Planning Commission Staff Report

Location: 17455 N. Outer 40 Rd.

Description: Larry Enterprises Jim Lynch Hummer, Lot A1, Parcel 2 (Porsche Service Center)
SDSP: A Site Development Section Plan, Landscape Plan, Lighting Plan, and Architectural Elevations for a 5.24-acre tract of land located north of N. Outer 40 Rd and east of Boone's Crossing.

Figure 5: Fenced parking area for loaner fleet

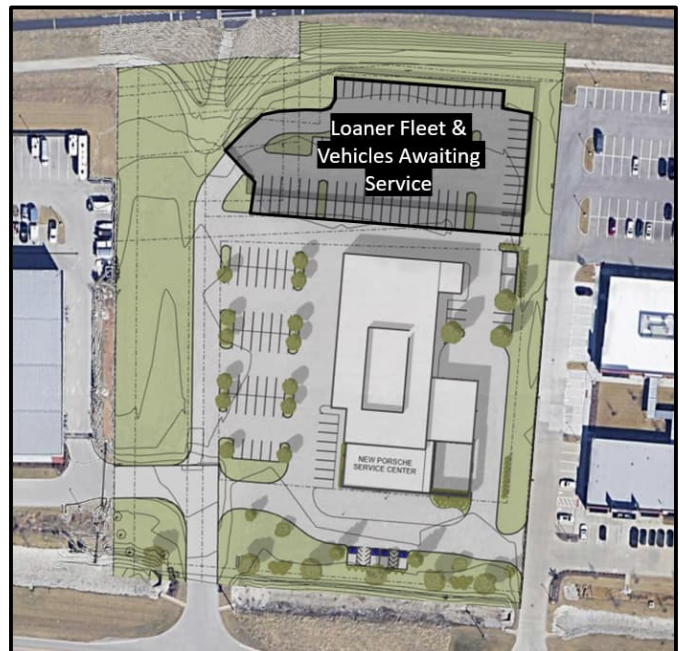
Aside from the parking that is available to the public, the developer is proposing one hundred four parking spaces on the north end of the site as shown in *Figure 4*. These spaces are to be fenced off and only available for vehicles awaiting service and/or the loaner fleet of vehicles that customers will use while their vehicles are away for service. Additionally, per Section 405.04.040, "Required off-street parking, stacking and loading spaces shall not include spaces located in the floodplain or floodway, as determined by the City of Chesterfield, except when accessory to a permitted or conditional use in the FP Floodplain Overlay District." The subject site is located adjacent to the Levee and therefore the northern portion of the site is in the Supplemental Protection Area (SPA).

Per the Unified Development Code, requests to exceed the maximum parking requirement shall be accompanied by a statement from the applicant that identifies measures to mitigate for the increase in parking area. Mitigation measures may include, but not be limited to, the following: 1) Increased openspace, 2) Pervious pavement, 3) Green roofs, 4) Cool pavement materials, 5) Structured parking, 5) Native vegetation.

The applicant has provided a statement detailing their proposed mitigation measures. These measures include providing increased openspace. The subject site is required to provide 35% openspace and there is 45.46% being provided. The provided narrative also details that the proposed building will be LEED certified which “signifies a certification that lowers carbon emissions, improves efficiency, and creates a healthier place for people” per the applicant.

Figure 7: Rendered east elevation

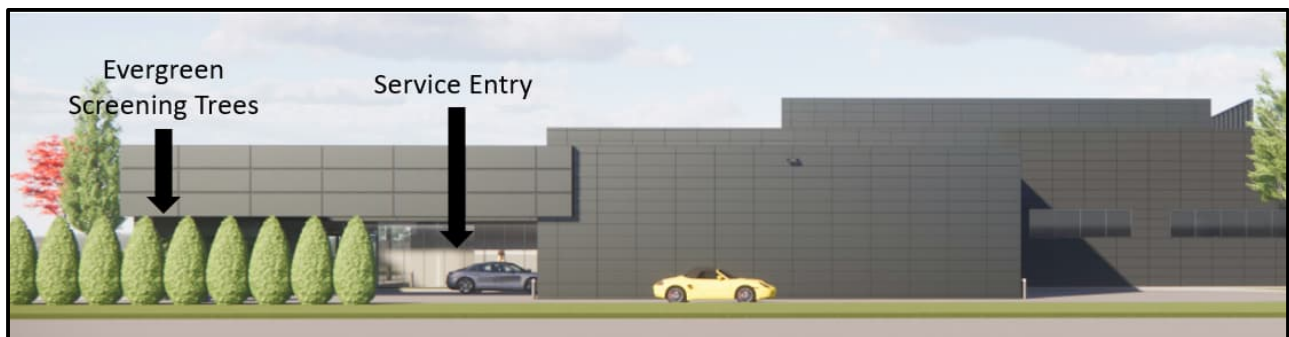
The subject site requires a thirty (30) foot landscape buffer along N. Outer 40 Rd. The applicant has provided a mixture of landscaping and street trees where allowed along the southern drainage channel. A series of nine (9) evergreen trees are proposed along the eastern property boundary to screen the automobile service entry from view as shown in the rendered east elevation in *Figure 7*.

Figure 9: Increased concrete detail and landscaping at entry

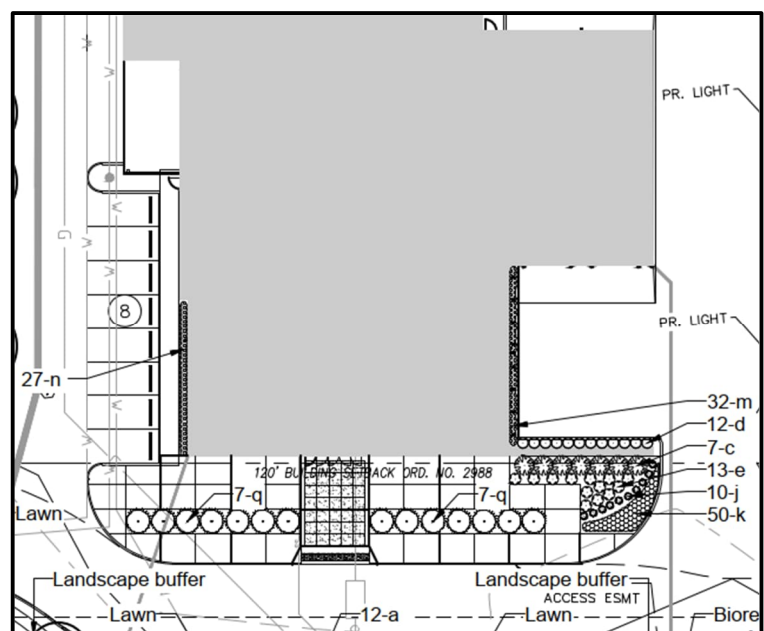
This project was reviewed by Architectural Review Board on July 13th, 2023. At that time, the Board made a motion to recommend approval with the following conditions:

- Provide additional information and a material sample of the rooftop screen wall patterns.
- Relocate the rooftop access door to the north end of the site.
- Consideration to omit the wall-mounted light on the south elevation.
- Provide a revised site plan depicting proposed paving patterns and increased landscaping along the front façade.

The submittal has since been revised to address all of Architectural Review Board's conditions. The most visible change will be the concrete scoring and additional landscaping at the entrance of the proposed building as shown in *Figure 9*.
